June 2021

Boston Scientific Advisory: High Battery Impedance May Initiate Safety Mode in INGENIO™ Family DR EL Pacemakers and CRT-Ps

Dear Physician or Healthcare Professional,

Figure 1. Programmer Warning Screen for Safety Mode

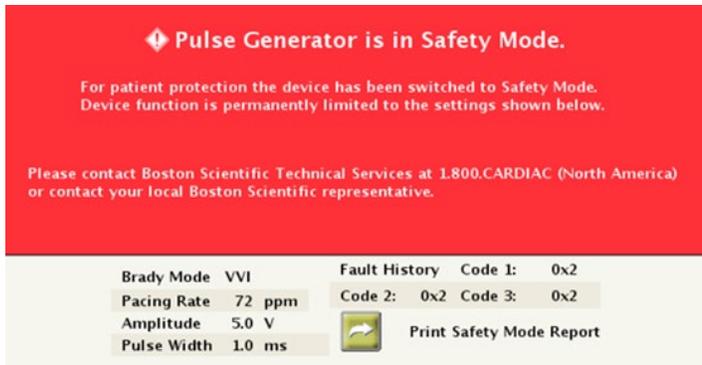
Boston Scientific has received reports associated with dual chamber INGENIO family pacemakers and CRT-Ps built with the EL battery (Appendix A), in which the devices transitioned to Safety Mode during interrogation attempts by either a programmer or a LATITUDE™ communicator. Investigation has shown that the EL battery impedance increases over time, based on implant duration and power usage. This increased battery impedance may cause a device to exhibit transient voltage decreases during periods of high-power consumption associated with telemetry communication via a programmer or a LATITUDE communicator. If the battery voltage drops below a minimum threshold during communication attempts, the device will temporarily halt telemetry, and a system reset will be performed. The battery voltage recovers and pacing function resumes within one (1) second; however, subsequent telemetry attempts may result in additional system resets due to the high battery impedance. If three (3) system resets occur within a 48-hour period, the device is designed to immediately enter Safety Mode to maintain back-up pacing with pre-defined, non-programmable settings (Table 1). There is no delay in resumption of pacing when the device enters Safety Mode. When a device is in Safety Mode, replacement is required.

Boston Scientific transvenous pulse generators contain dedicated hardware to support overall safety architecture. In pacemakers and CRT-Ps, this hardware is intended to provide back-up pacing if certain non-recoverable or repeat fault conditions occur. Safety Mode is not intended to be a substitute for chronic pacing therapy. There is a high degree of detectability when a device is operating in Safety Mode. A warning screen is displayed on the programmer upon device interrogation (Figure 1). For those devices monitored via LATITUDE, a red alert will also be issued, indicating the device has entered Safety Mode. If a device is unmonitored for a period of 14 days, it will show up on the 'not monitored' status page on LATITUDE. Whenever a device enters Safety Mode operation, users are instructed to contact Boston Scientific, and Technical Services will advise device replacement.

2. Replacement. If a device enters Safety Mode, schedule replacement. Boston Scientific does not recommend general prophylactic replacement for affected devices. However, for individual patients, factors such as those listed above and shared decision-making may support consideration of early device replacement to mitigate unintended clinical impact(s) due to potential entry into Safety Mode prior to the Explant indicator. In these cases, the following guidance should be considered:
